**Notice of Allowability**

09/877,585

BASFORD, WILLIAM COLIN

**APPARATUS TO REDUCE BASE DRAG  
BEHIND BLUFF BODIES (as amended)**

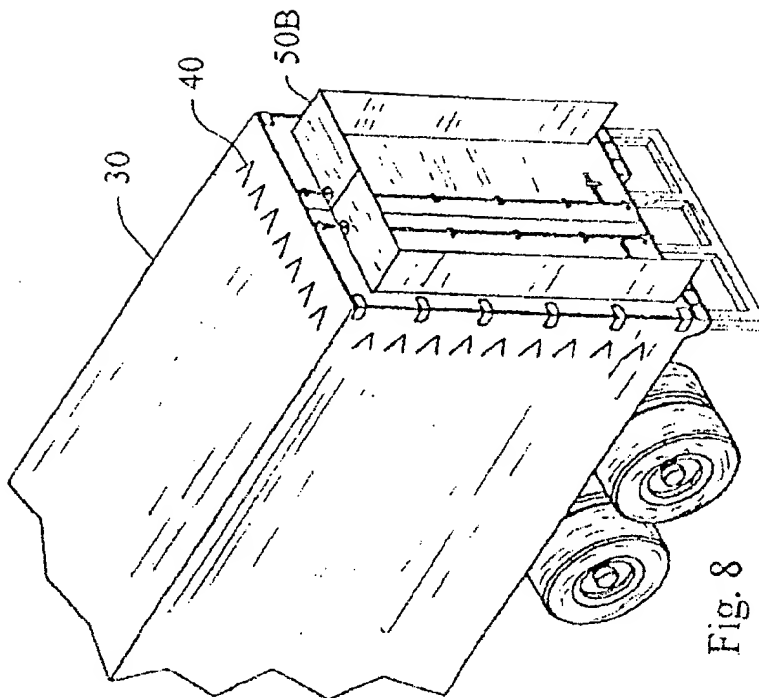
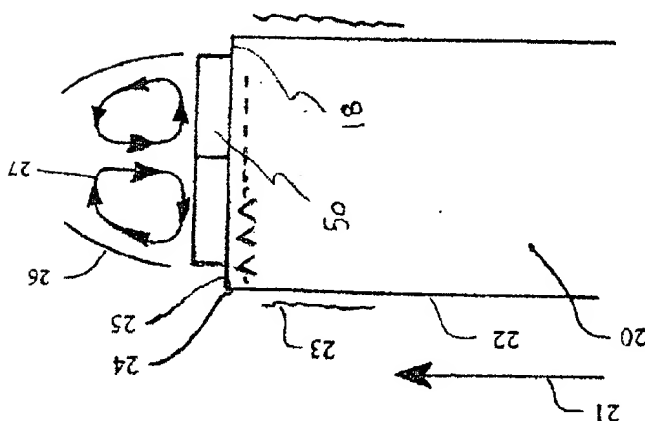
Fig 8 has been amended as per the attached proposed Fig 8, which will be further amended to incorporate reference number for limitations of claim 33.
